ADDENDUM #1

Date: April 17, 2025

Project: Tierney Park Improvements Project

Owner: Village of Lexington, Michigan

GP-1.02

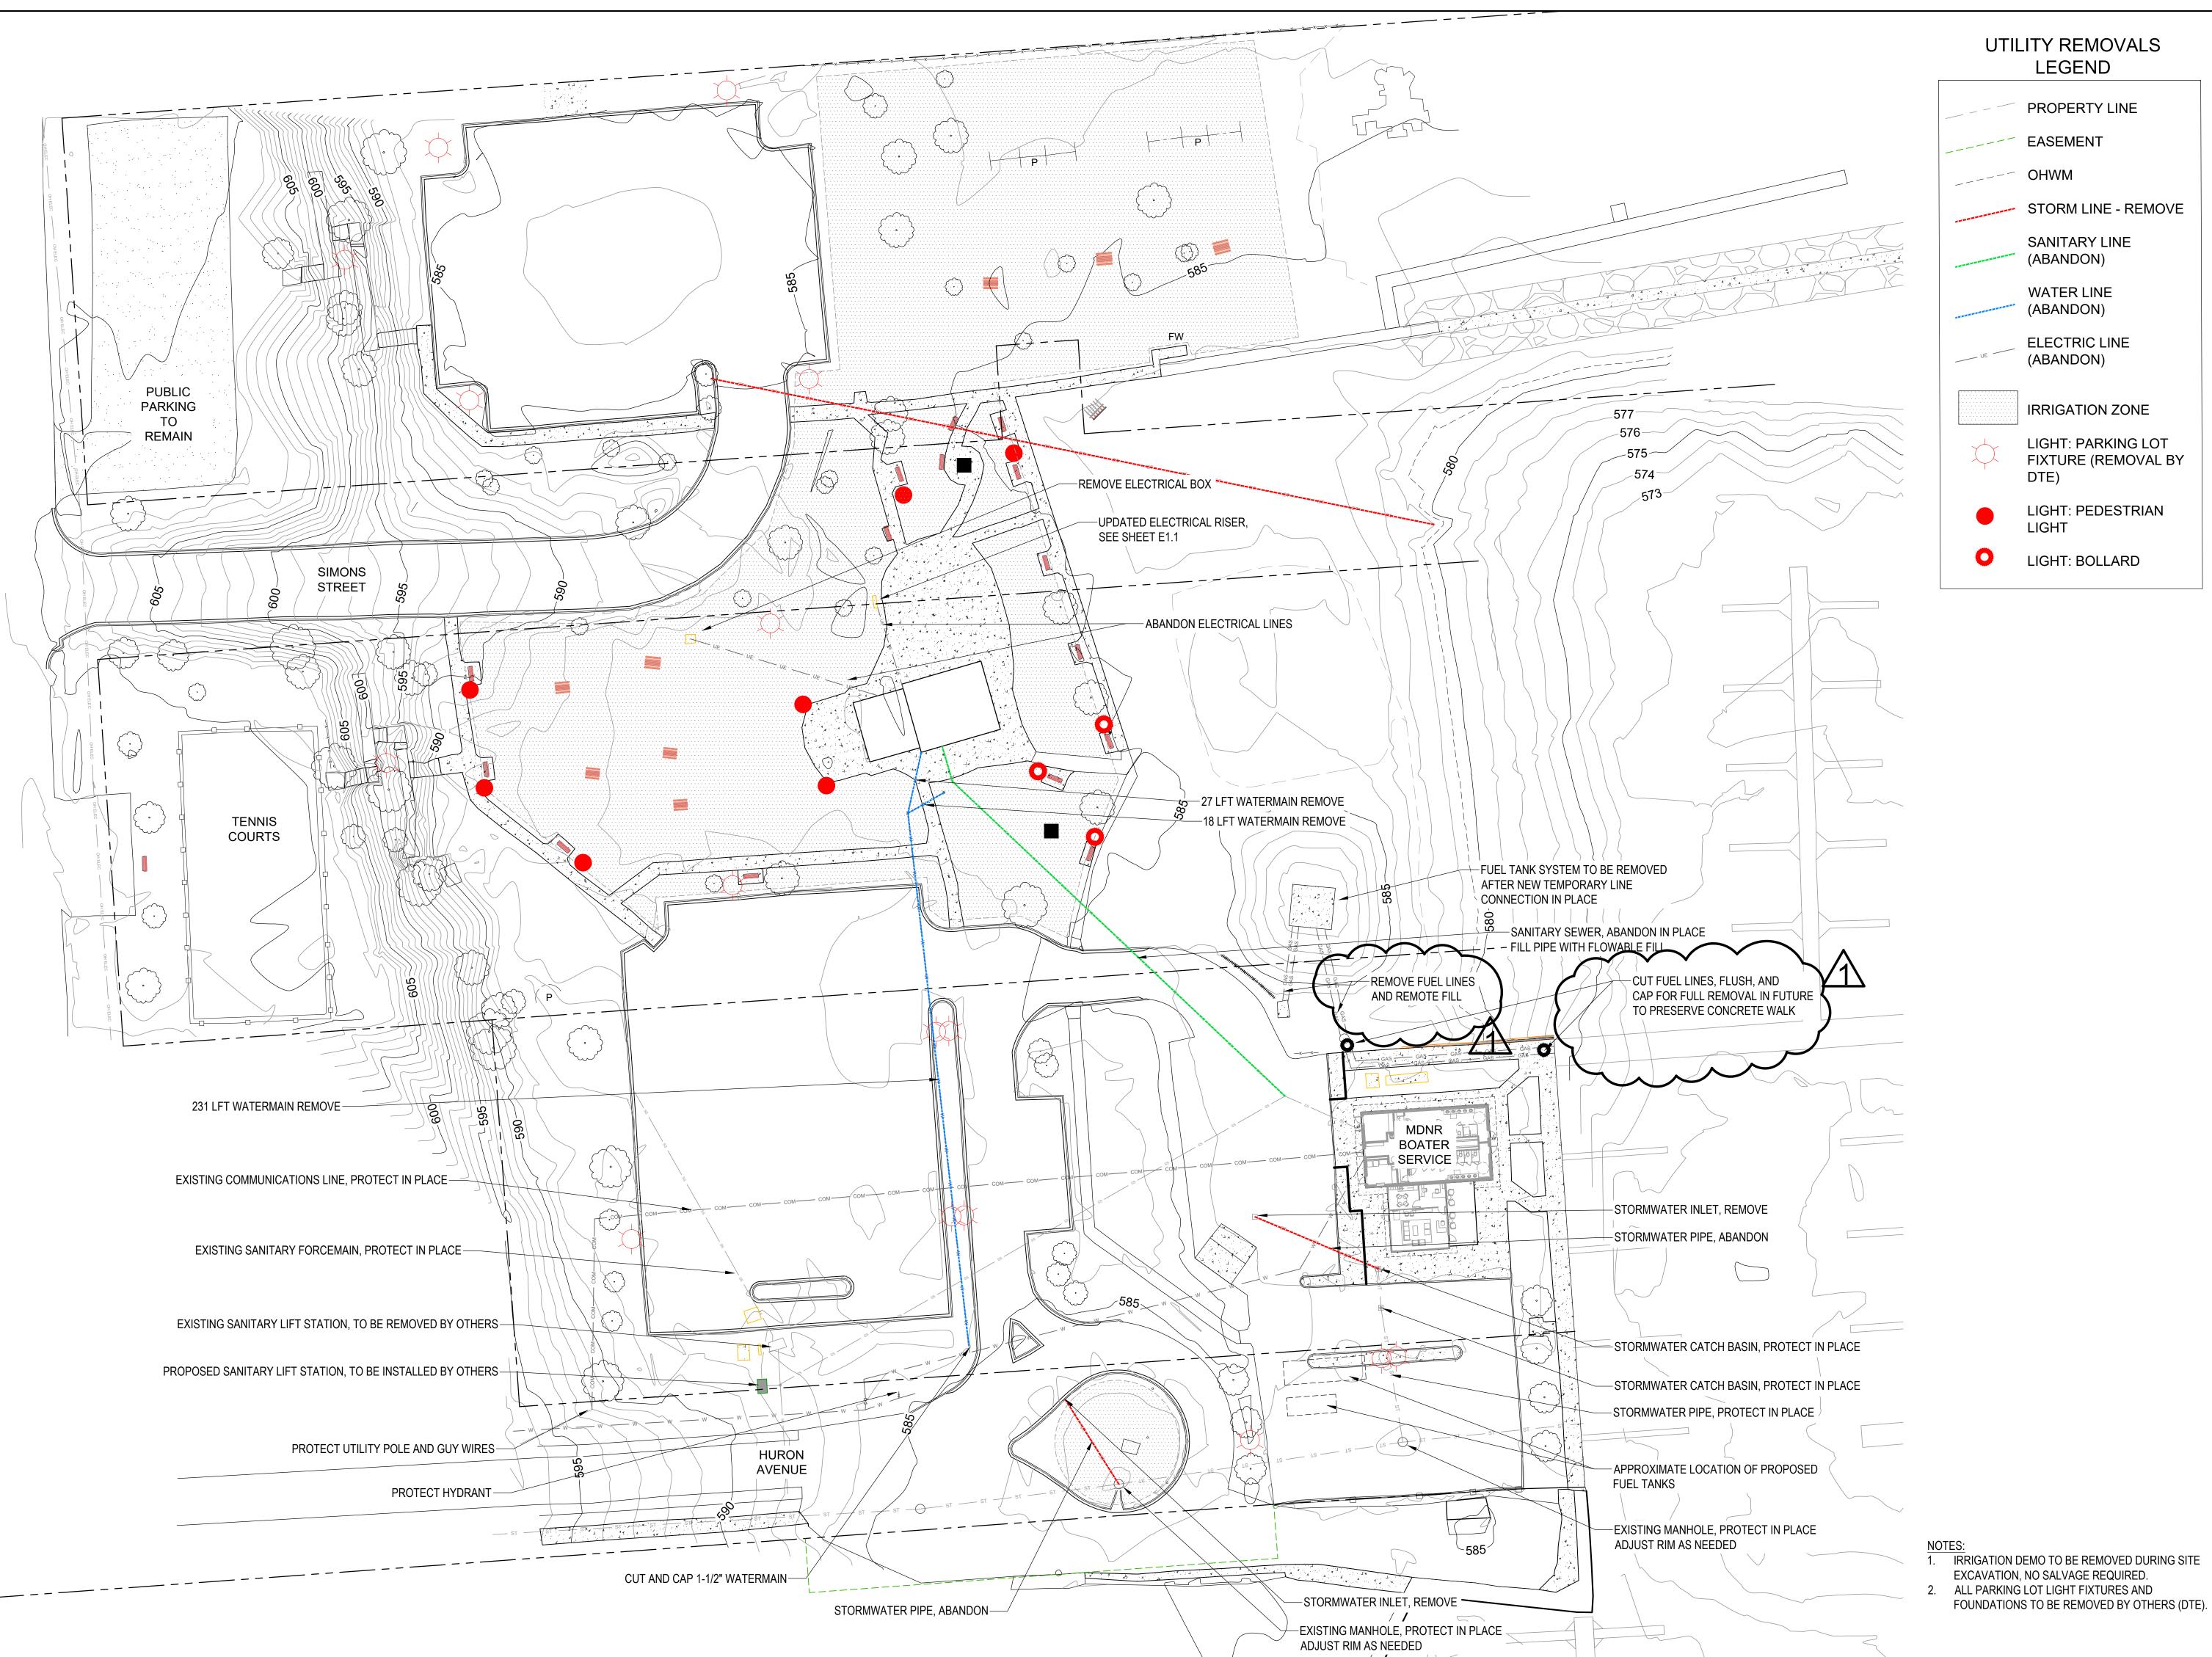
- 1. **GP-1.02** Construction Sequencing Plan
 - a. Date for Marina Access extended to 10/15/25
- 2. **UD-1.01** Utility Demolition Plan
 - a. Fuel line label clarification

U-1.01

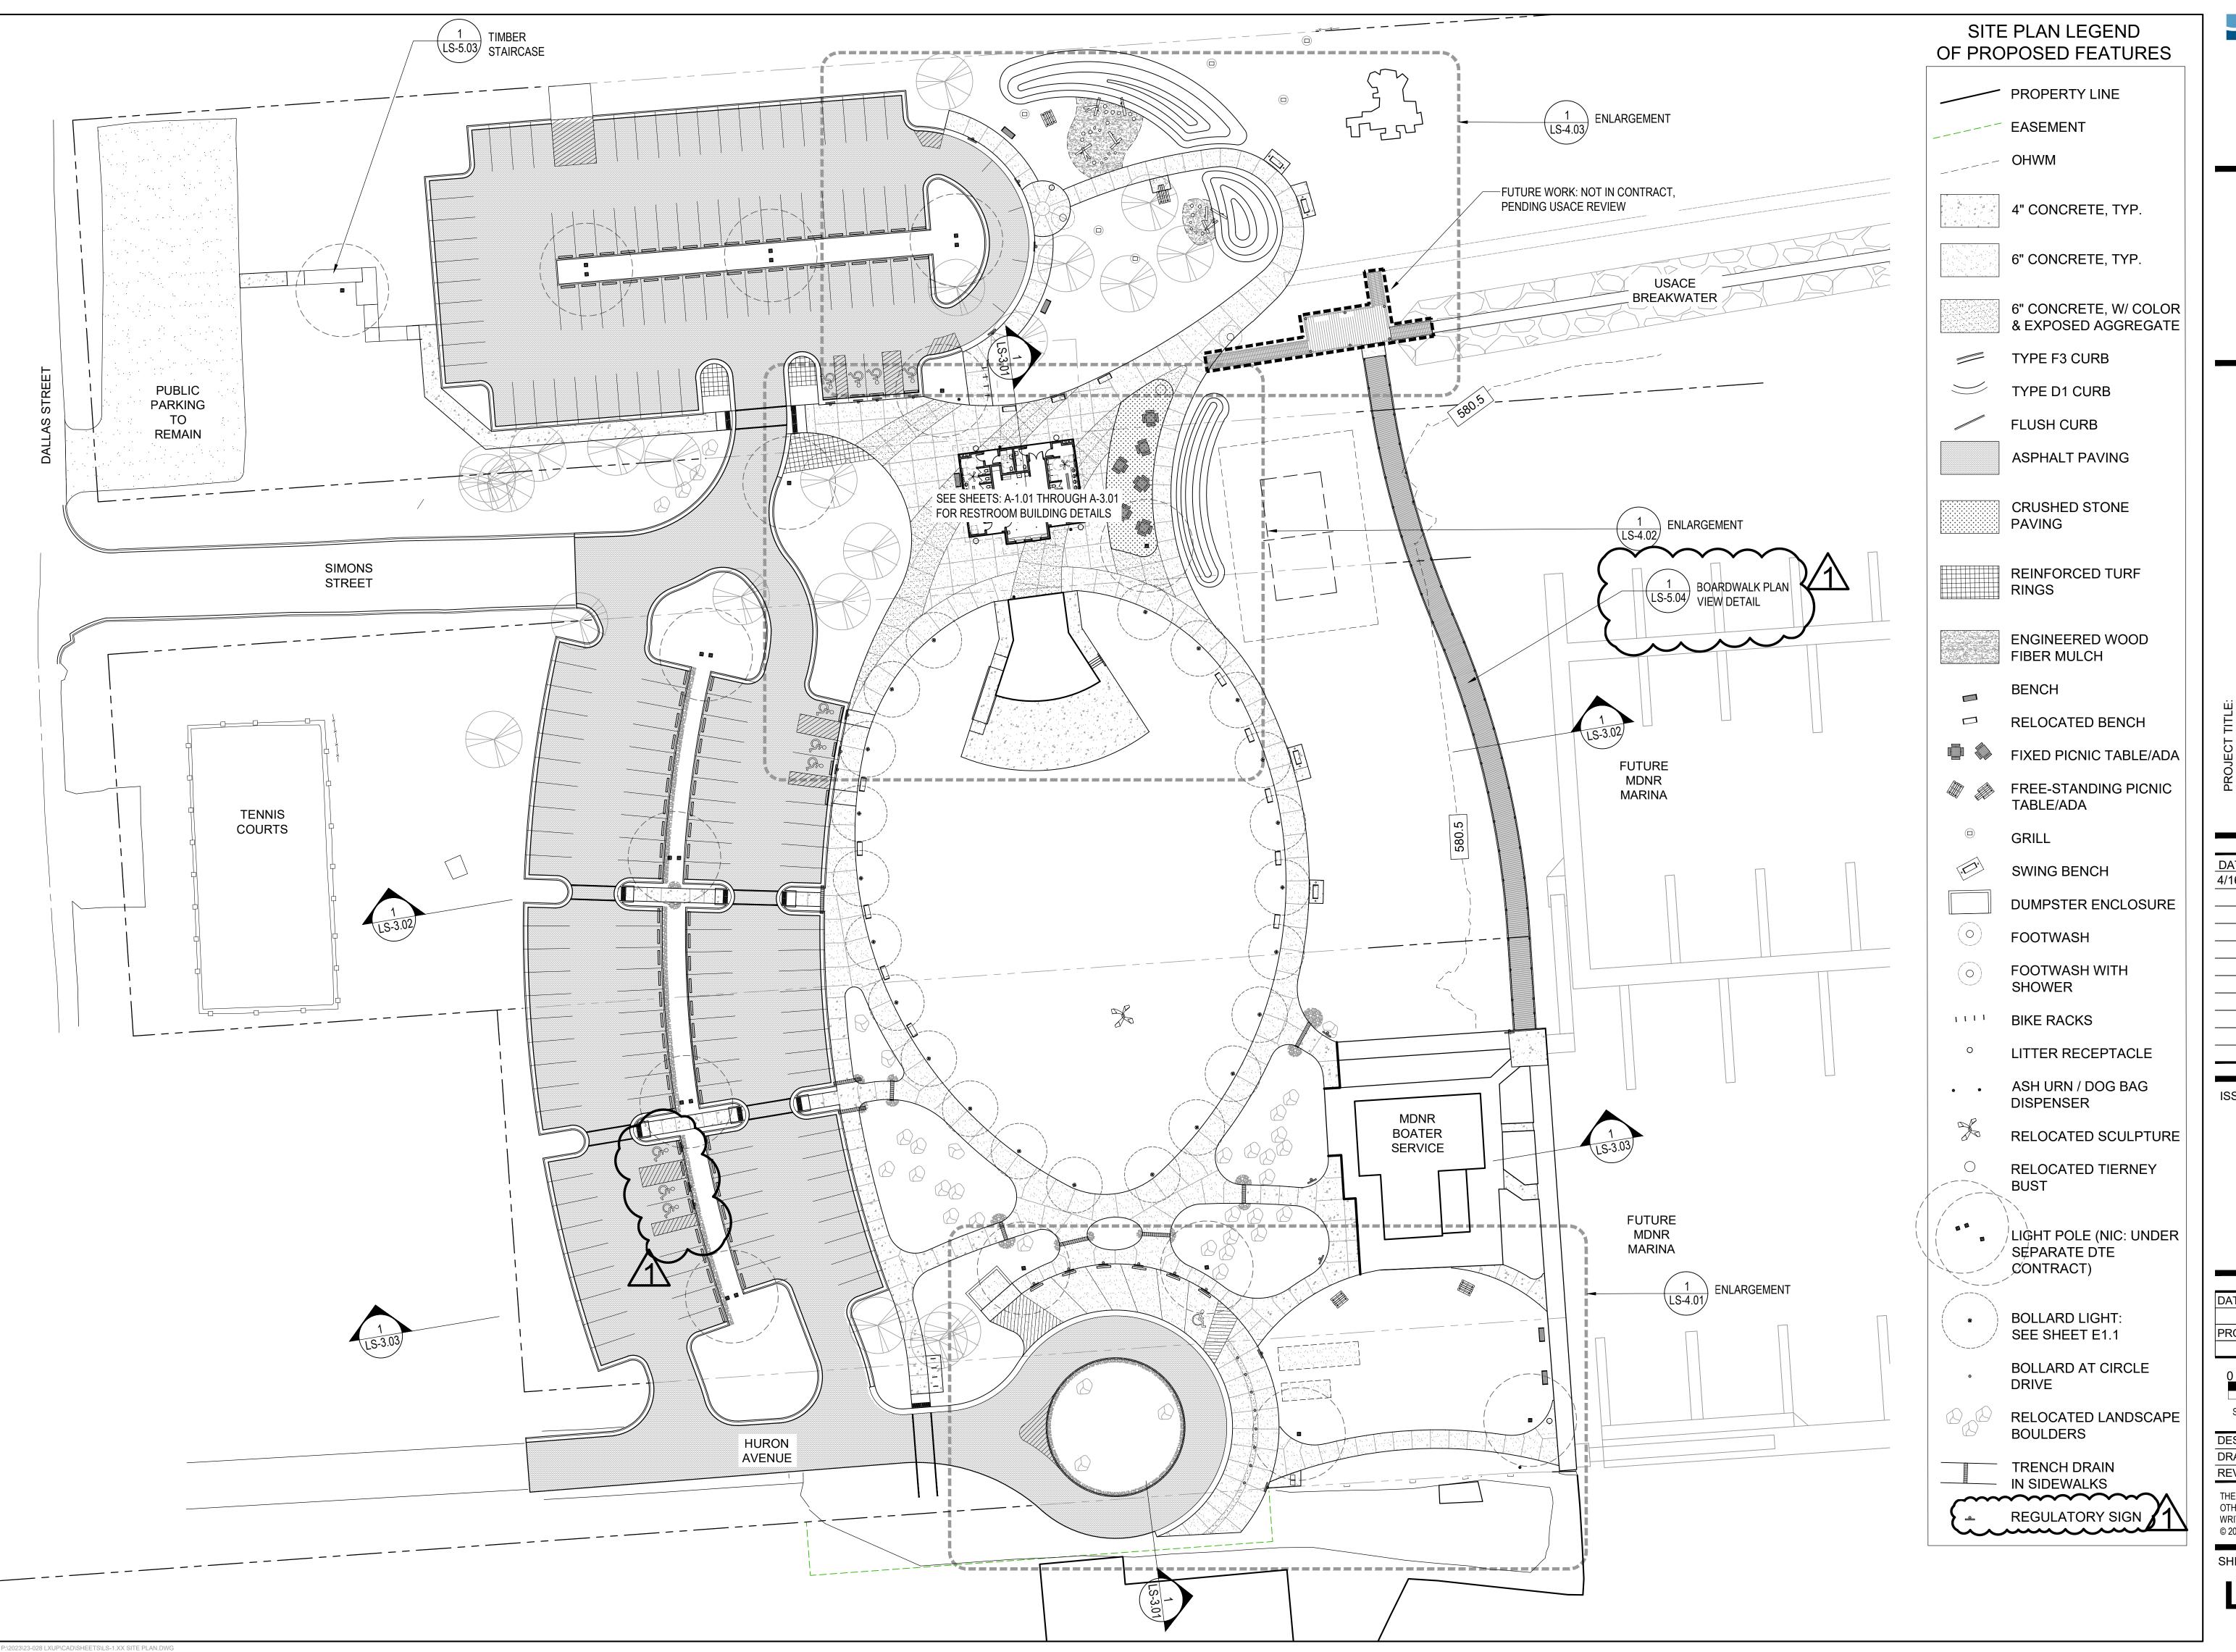
- 3. **U-1.01** Utility Plan
 - a. Label removed regarding hydrant (no hydrant in contract)
- 4. LS-1.01, LS-1.02, LS-1.03 Site Plan and Control Points Plans

- 1. Q: On the Utility Plan sheet 1.01 it shows us putting in a new hydrant, but it doesn't clearly show us what we are tying it into.
 - A: No new hydrant is proposed. Label will be removed from sheet.
- 2. Q: Will EV chargers be added to the parking lot?
 - A: No, if EV charging parking spaces are added in the Village, they will be near downtown area, not in Tierney Park.

LS-1.01

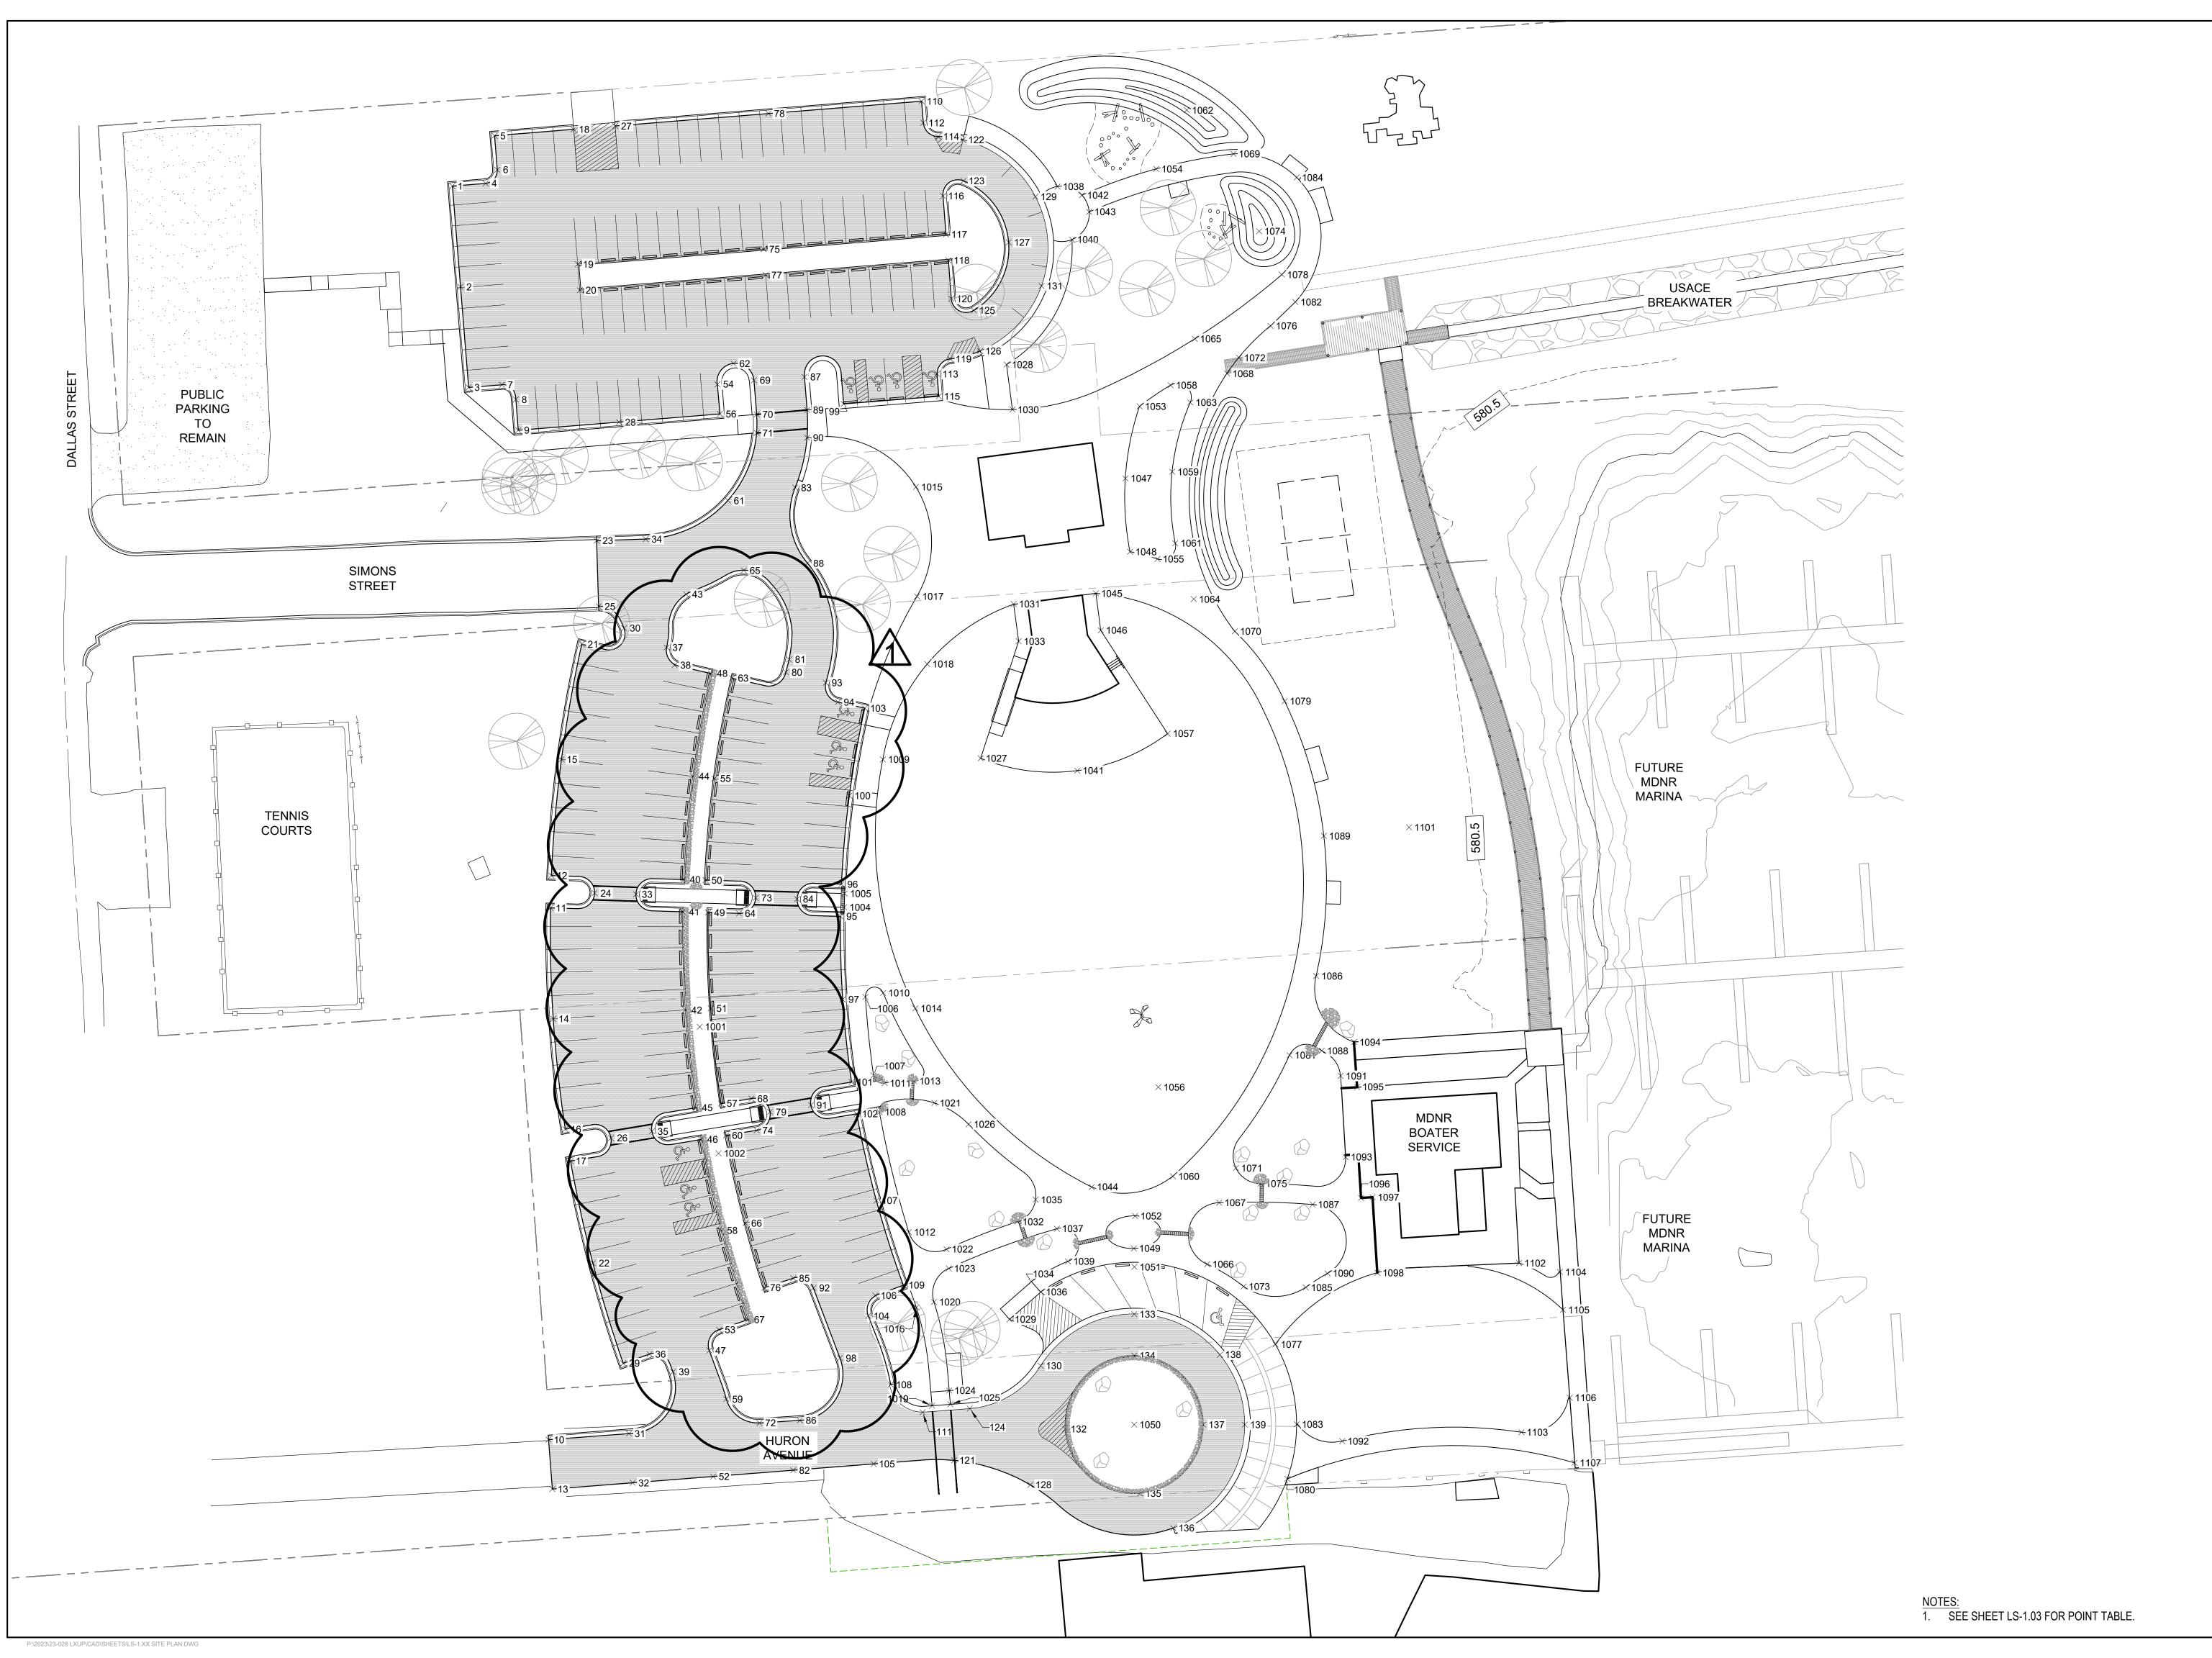
- a. Width of drive aisle between parking bays increased by 2'
 - b. Striping for handicap parking spaces added in southwest parking bay
 - c. Regulatory sign locations added
